# HISTORIC AND DESIGN REVIEW COMMISSION

**HDRC CASE NO:** 2020-165  
**ADDRESS:** 611 N OLIVE ST  
**LEGAL DESCRIPTION:** NCB 562 BLK 8 LOT N 60 FT OF 16,17,&18 & E 52.08 FT OF W 104.16 FT OF 10 ARB 21  
**ZONING:** R-6, H  
**CITY COUNCIL DIST.:** 2  
**DISTRICT:** Dignowity Hill Historic District  
**APPLICANT:** Yusra El-Hibri  
**OWNER:** Yusra El-Hibri/Y DESIGNS LLC  
**TYPE OF WORK:** Landscaping and site work  
**APPLICATION RECEIVED:** April 06, 2020  
**60-DAY REVIEW:** Not applicable due to City Council Emergency Orders  
**CASE MANAGER:** Edward Hall  
**REQUEST:**

## 611 N OLIVE FRONT LANDSCAPE & WALK WAY

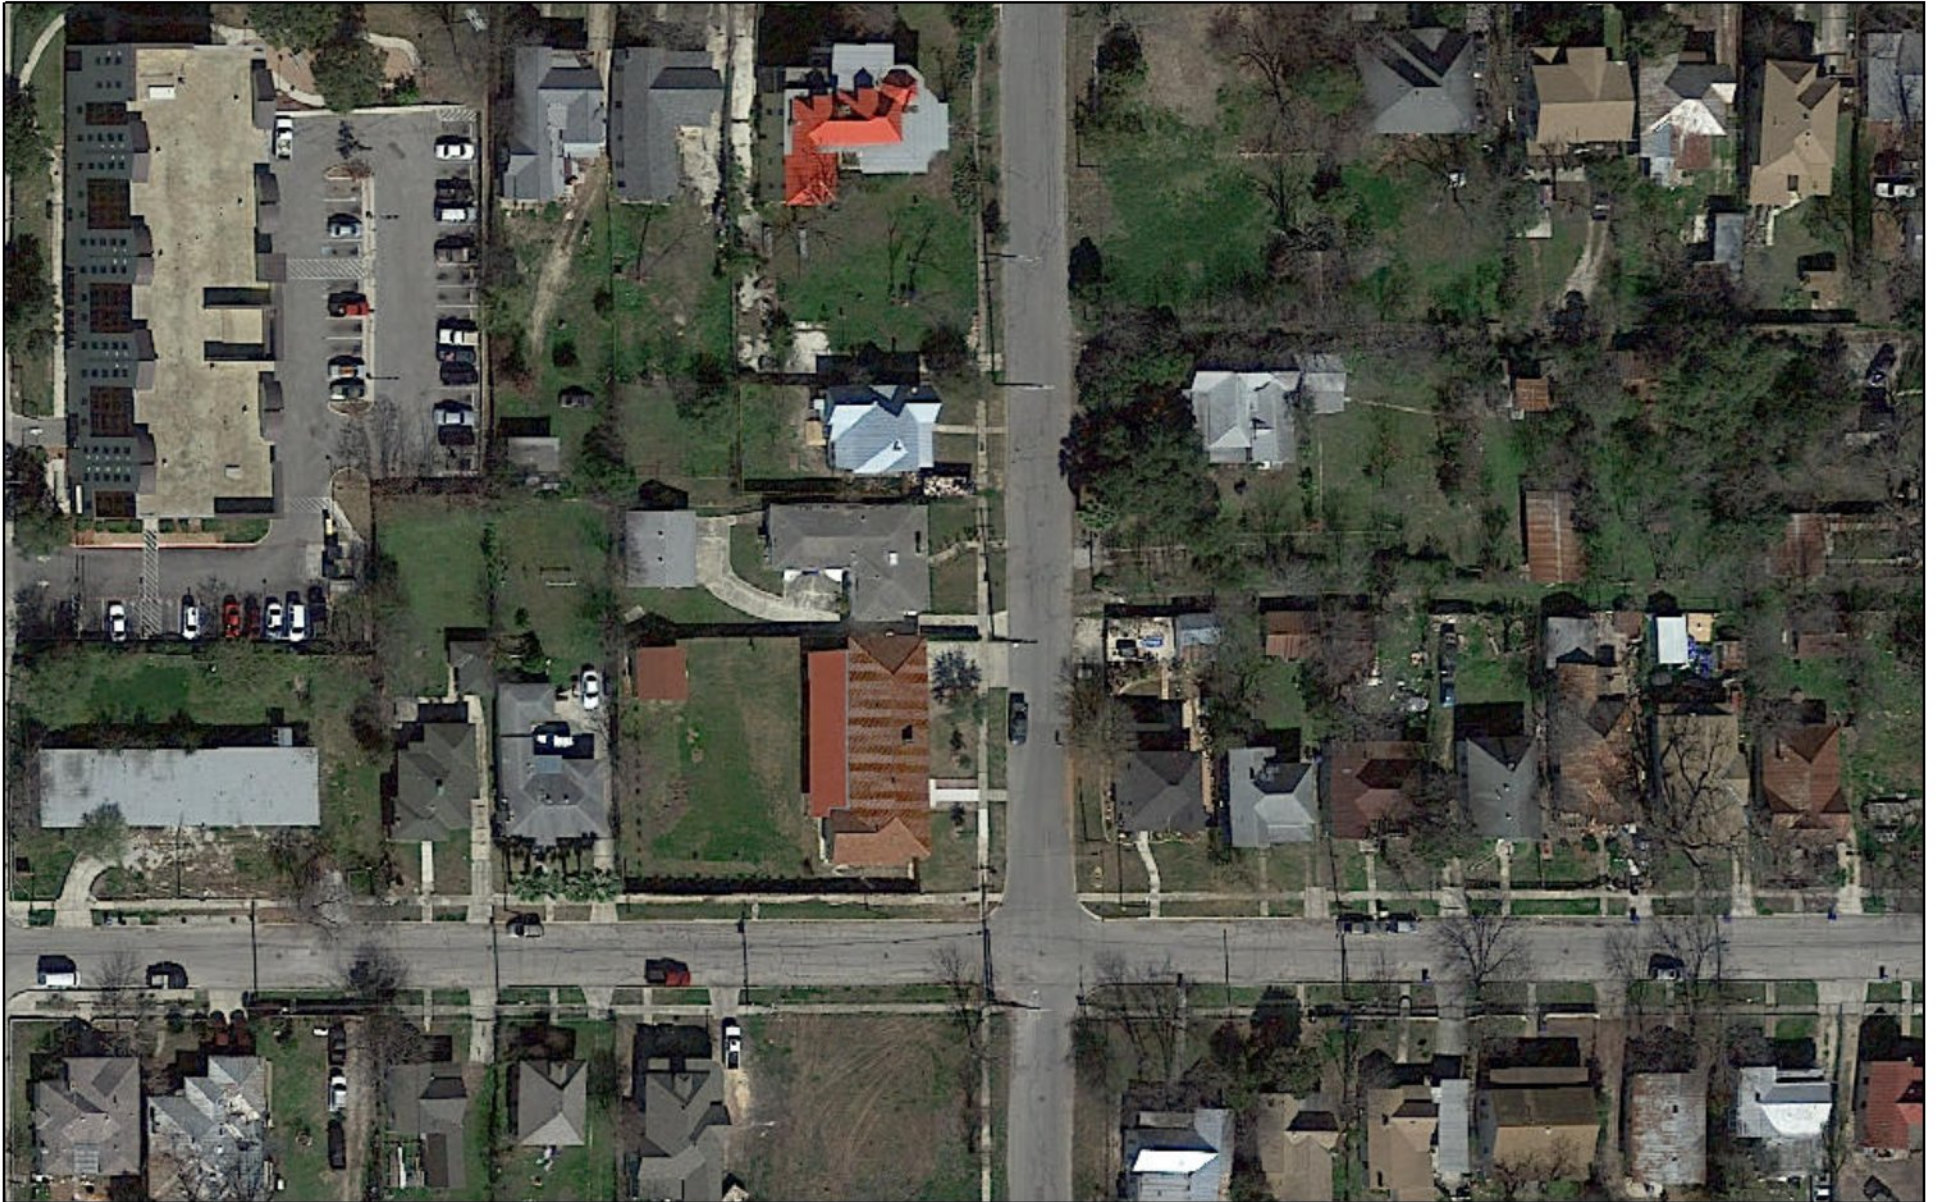
- b. DRIVEWAY – The applicant has proposed to install a concrete ribbon driveway to feature gravel between the paving strips, as well as a gravel border. The proposed ribbon strip driveway will replace an existing concrete driveway. Per the Guidelines for Site Elements 5.B.i. new driveways should feature similar materials, widths and designs as those found historically within the district. Driveways should not exceed ten (10) feet in width. Staff finds the proposed ribbon strip driveway to be appropriate; however, the width should not exceed ten (10) feet in width, including the gravel borders.

- c. WALKWAY – The applicant has proposed to remove the existing, curved front yard walkway and install a straight, concrete paver walkway. Staff finds that the curved profile of the existing walkway is atypical for the predominant profile found historically within the district, and that its removal is appropriate. Staff finds that a replacement walkway should be consistent with the Guidelines for Site Elements; the replacement material should match the existing in color and material, and that the historic alignment, configuration and width of sidewalks throughout the district should be used. Staff finds that the proposed walkway should feature a continuous concrete walkway that is three to four feet in width. Additionally, the walkway between the public sidewalk and curb should be aligned with the front door.

- d. LANDSCAPING – The applicant has proposed to install a landscaping bed in front of the front porch to feature xeric plants and gravel. Staff finds the proposed planting bed to be appropriate.

- i. That the proposed concrete driveway not exceed ten (10) feet in width, including the proposed gravel borders.
- ii. That the proposed walkway feature a full concrete profile in place of the proposed pavers. Additionally, the proposed walkway should feature three to four feet in width, and the existing walkway between the sidewalk at the right of way and the curb should be relocated to align with the proposed walkway and front door.
- iii. That all gravel feature a natural color.
